MFN 06-264 Supplement 1

Docket No. 52-010

Subject: **Response to Portion of NRC Request for Additional Information
Letter No. 18 - Reactor Building Subcompartment Pressurization
Analysis - RAI Number 6.2-46 S01**

RAI Number 6.2-46 S01

Figure 6.2-18. RWCU/SDC System Subcompartment Pressurization Analysis (Sub-Model 1)

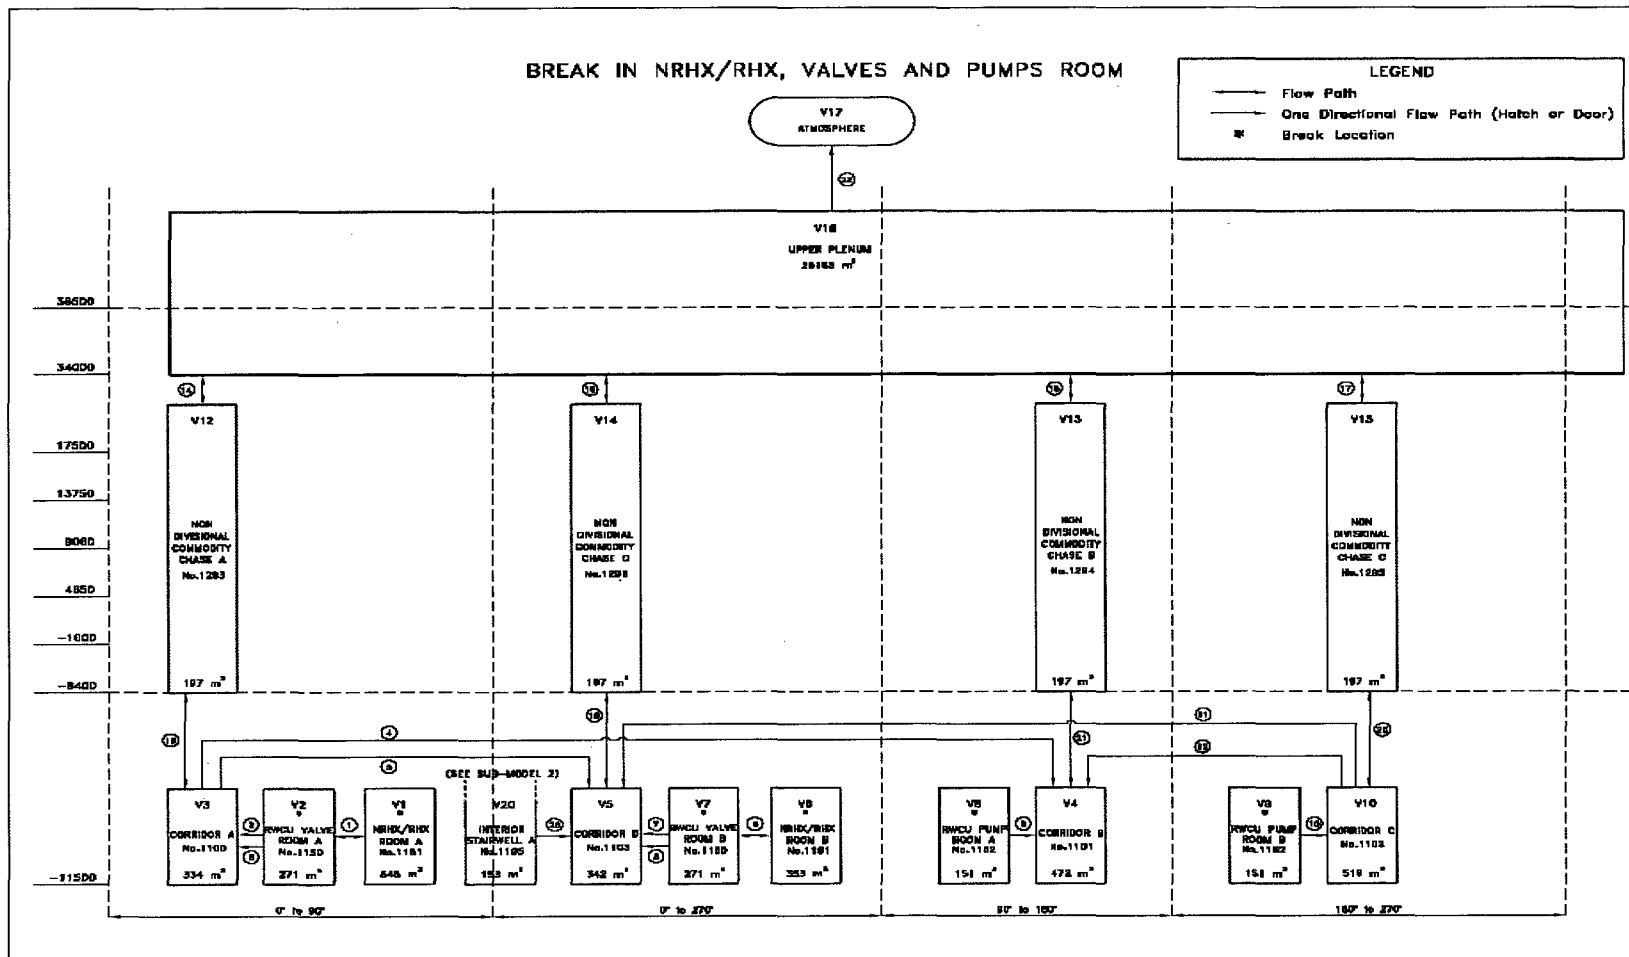
- (3) *The volumes of cell nos. 12 through 15 are given as 197 m³ in the input file but 565 m³ in DCD Table 6.2-12a.*
 - (4) *The volume of cell no. 11 is listed as 151.49 m³ in the input file but 94 m³ in DCD Figure 6.2-18 and 152 m³ in DCD Table 6.2-12a.*

- (3) DCD Tier 2, Figure 6.2-18, will be revised to change the volumes of cells 12, 13, 14 and 15 from 565 m³ to 197 m³.
- (4) The volume of cell 11(extended model) is 94 m³ as shown in DCD Tier 2, Revision 3, Figure 6.2-18 (Sub-Model 2). In the short CONTAIN model, cell 11 is fictitious.
- DCD Tier 2, Table 6.2-12a, will be revised to change the volumes of cells 12, 13, 14 and 15 from 565 m³ to 197 m³, and the volume of cell 11 from 152 m³ to 94 m³.
- (5) The CONTAIN input file for the extended model is consistent with the proposed revision to DCD Tier 2, Figure 6.2-18, attached to this response.

- A. DCD Tier 2, Table 6.2-12, will be replaced in DCD Tier 2, Revision 4, as shown in the attached markup. DCD Tier 2, Table 6.2-12a, and DCD Tier 2, Figure 6.2-18, will be revised in DCD Tier 2, Revision 4, as shown in the attached markup.
